**Sunnyside Cogeneration Associates**

RE: Sunnyside Cogeneration Associates (SCA)
Sunnyside Refuse and Slurry C/007/0035
Permit Amendment – East Access Road – W
DOGM Review task #5508

SCA is submitting the enclosed updated permit amendment package to address comments received in your September 8, 2017, review letter Task #5508 associated with the East Access Road W submittal. Changes are as follows:

**Permittee:** SUNNYSIDE COGENERATION ASSOCIATES
**Mine:** SUNNYSIDE REFUSE & SLURRY **Permit Number:** C/007/035
**Title:** East Haul Road - W

SHEET 5-2

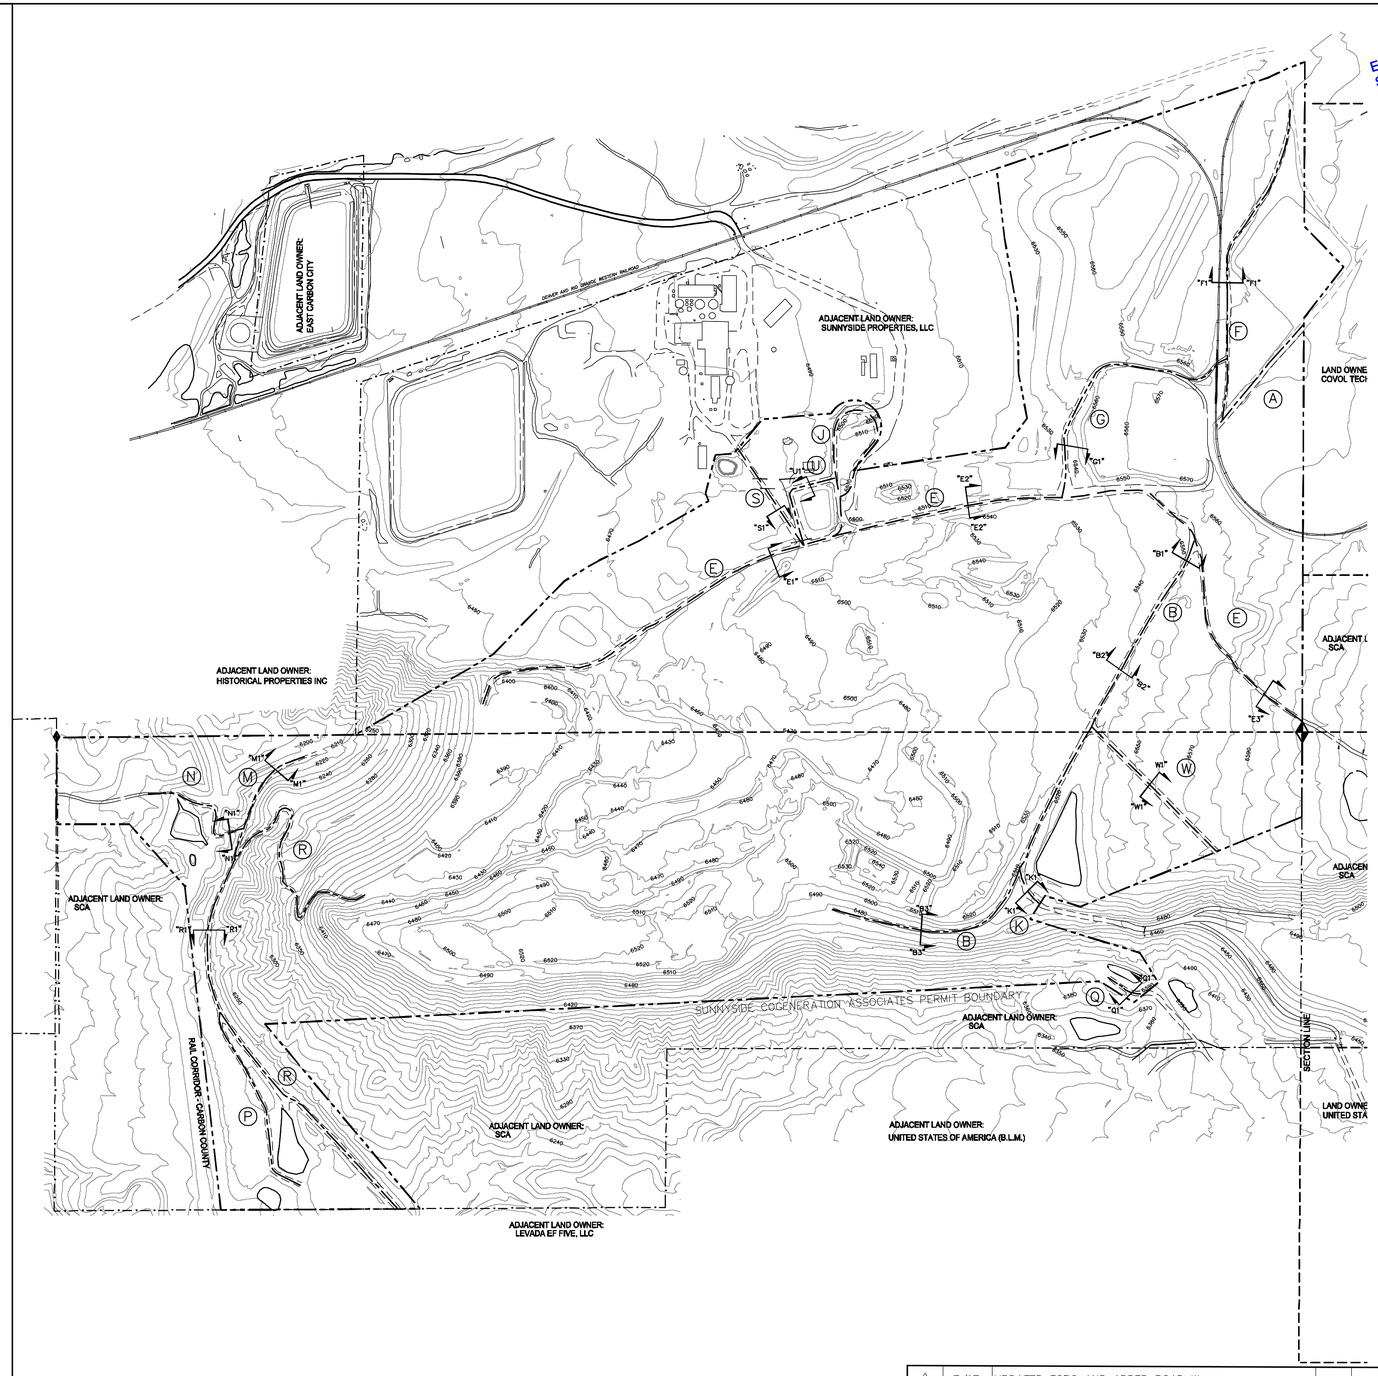
Maps Facilities – R645-301-521.141
Please clarify the permit boundary shown in the SE corner of all maps included in the application (by road K), because they are inconsistent with the permit boundary shown on approved maps in the MRP.

- A permit boundary change in the SE corner was submitted by SCA separately and prior to the Road W amendment. This permit boundary change was approved by the Division on Aug 30, 2017 (Task #5499). Clean copies have been submitted to the division for incorporation. Maps included in the Road W amendment application were prepared to reflect the boundary as had been submitted and as is now approved.

DESIGNED AH
DRAWN AH
CHECKED SSC
SHEET
5-2G

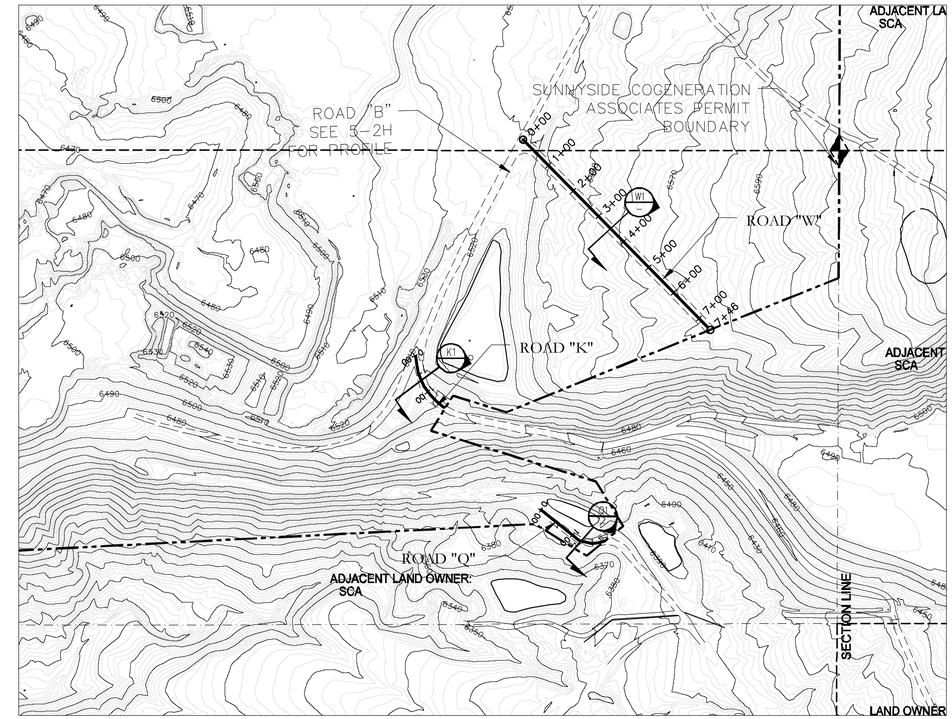
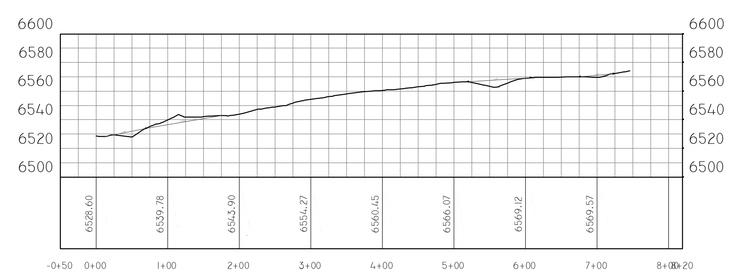
Topsoil and Subsoil – R645-301-233
The application should indicate that the public access across the Reclamation borrow area is temporary. During operations, signs should be placed along the road to discourage off-road travel into the borrow area. The application should describe the status of the road at reclamation, whether it will be replaced or reclaimed. Plans for handling compacted road soils and imported road base (if any) should be described in the reclamation plan.

- The access and use of the proposed Road W is not intended as open for the general public. The road is on private property and accesses private property. Access is only available to those authorized by SCA and is controlled by SCA since they must first

come through the front gates of the SCA facilities. Signs to discourage off-road travel into the borrow area are not necessary as off-road vehicles and travel are not allowed on SCA property and authorized users will be informed about the off-road policy. Road W is temporary and will be removed at the time of reclamation. Any road base materials used in constructing and maintaining the road will be removed during reclamation and compacted soils under the road surface will be ripped and loosened as part of the reclamation process. We have added language to the permit reflecting these conditions.

7-1

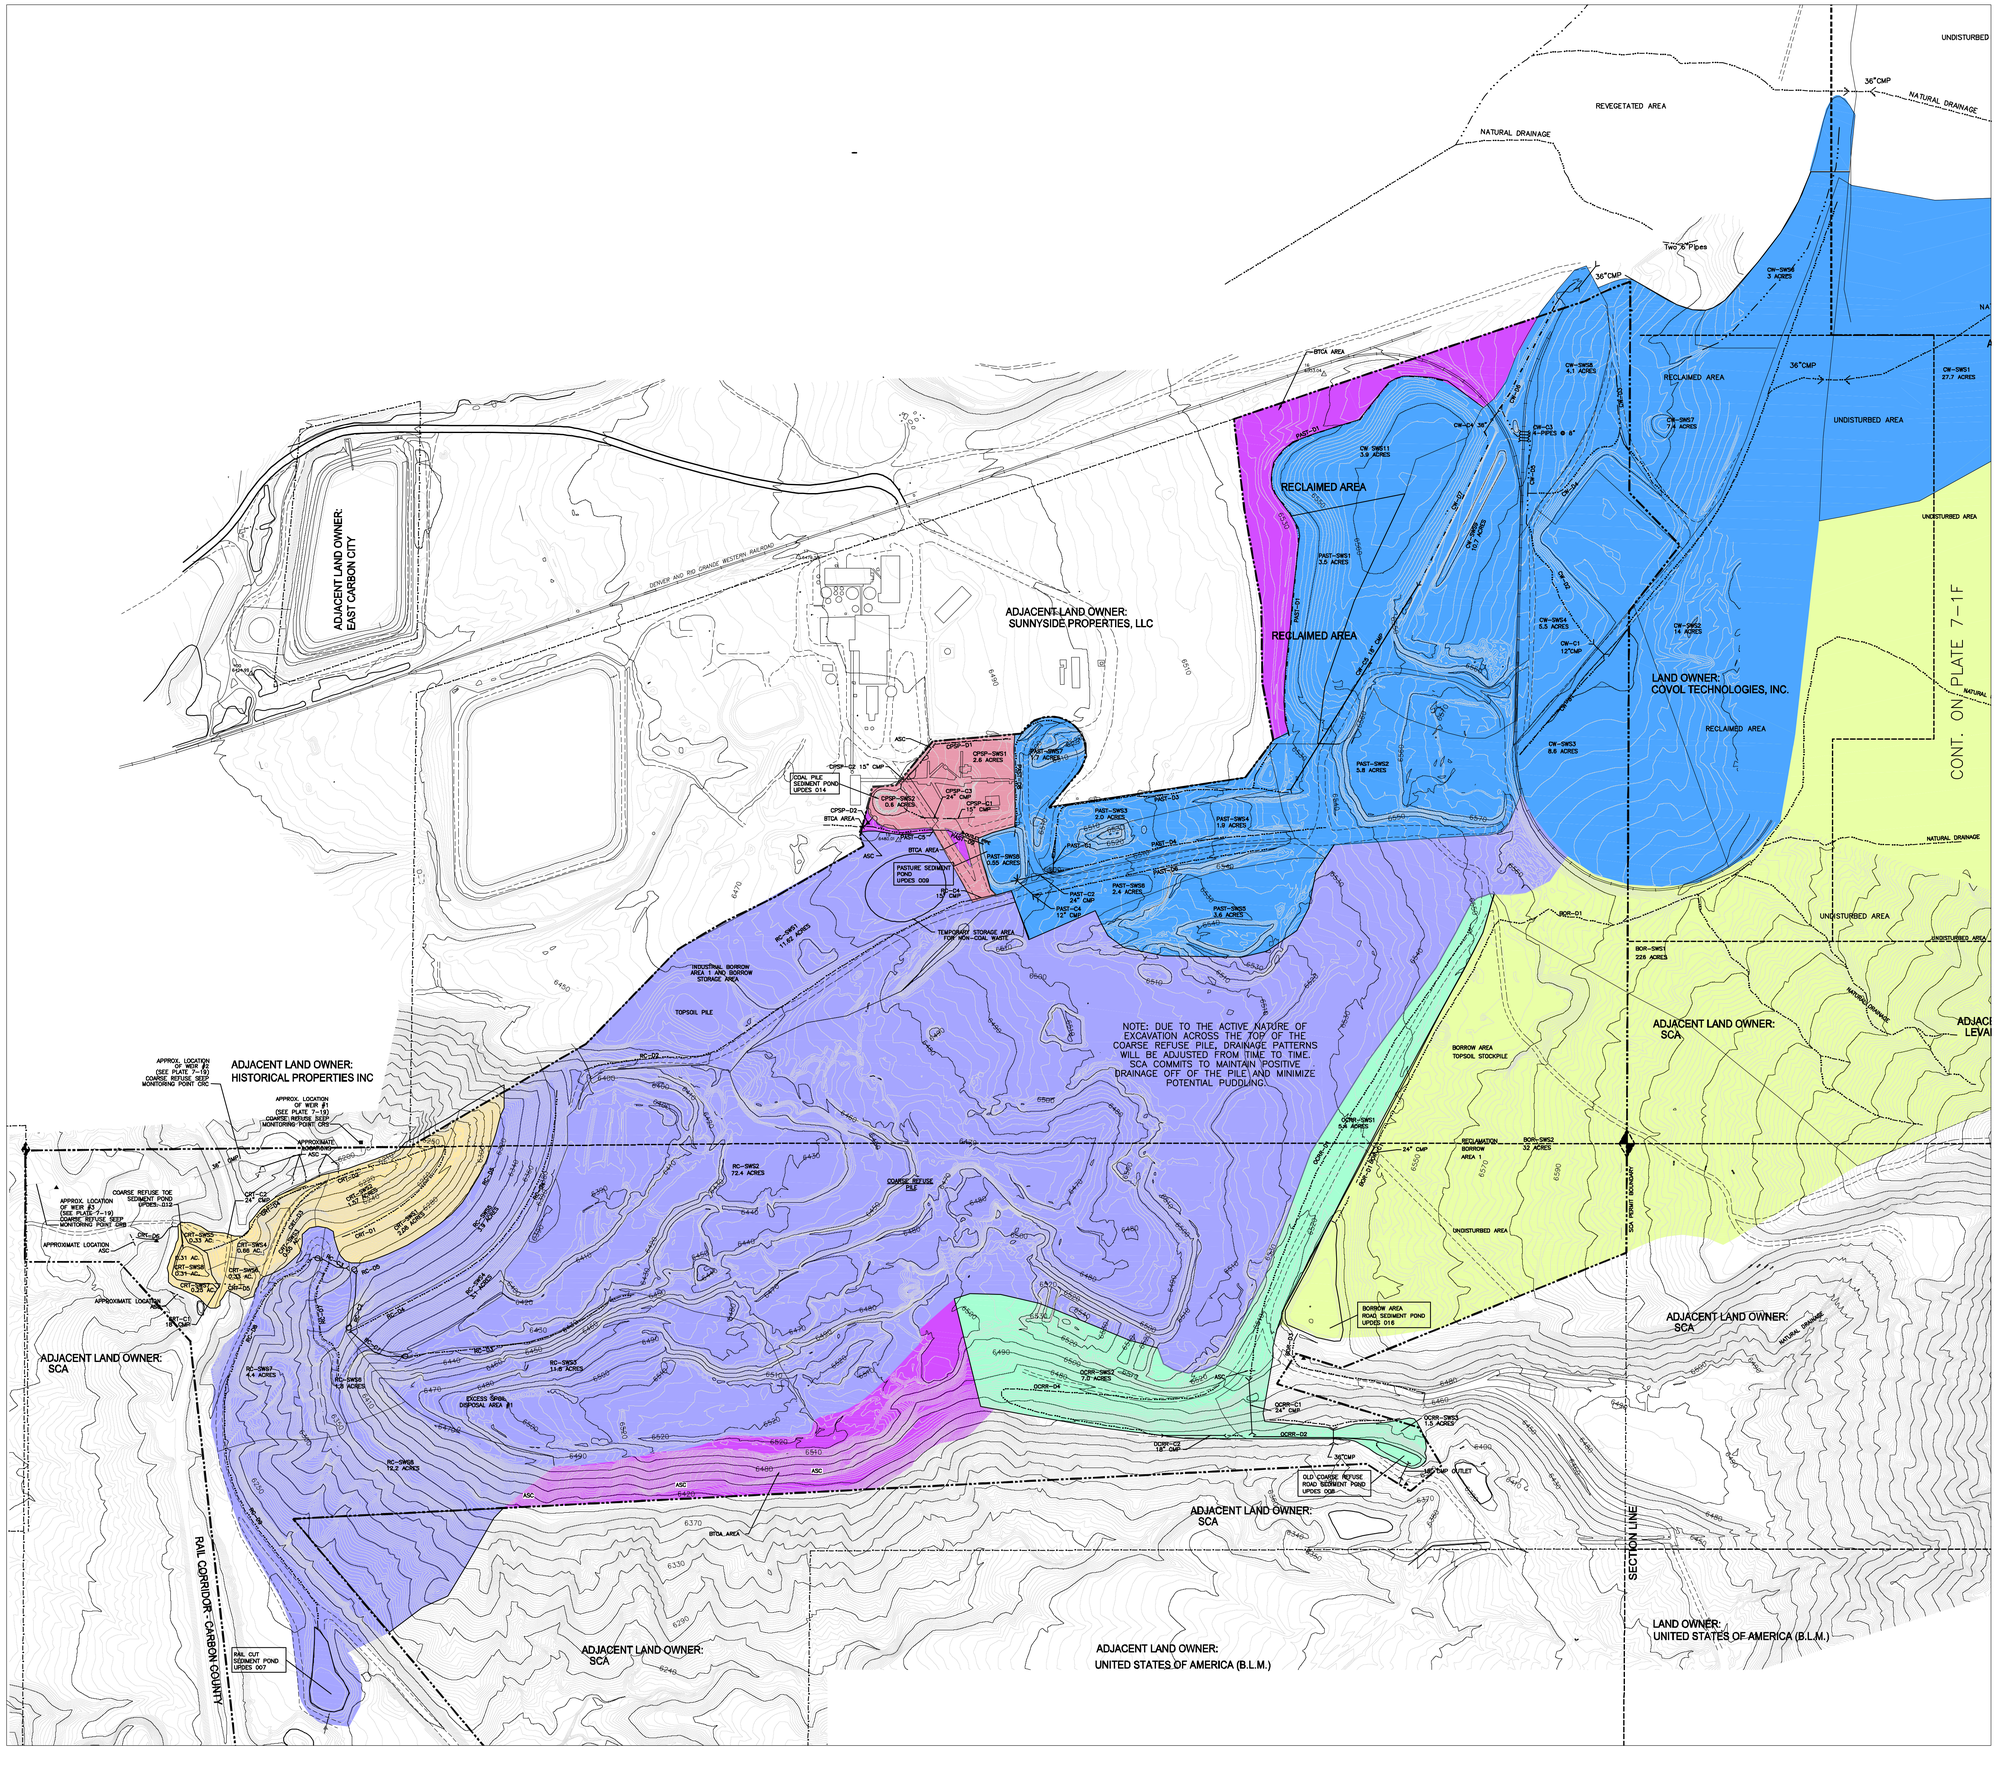
Hydrologic Diversion – R645-301-121.200
The Permittee must update the MRP to reflect the addition of Road W. Appendix 7-3 must be updated to include the addition of BOR –C1

Hydrologic Diversion – R645-301-742.423.3
The Permittee must include a narrative describing how the culvert design will prevent the functions of the sediment control structures from becoming impaired in the event of debris from the drainage area, i.e. use of trash racks.

- As noted in the review analysis, the MRP already contemplates the need for BOR-C1 and was designed many years ago as a culvert that would be added in the future. We have removed original references in Appendix 7-3F page 4 which previously referred to this culvert as "not needed at this time" and references that this culvert would be needed "in the future".

- Appendix 7-3F page 4 now calls for a trash rack to be installed at the upstream side of this culvert.
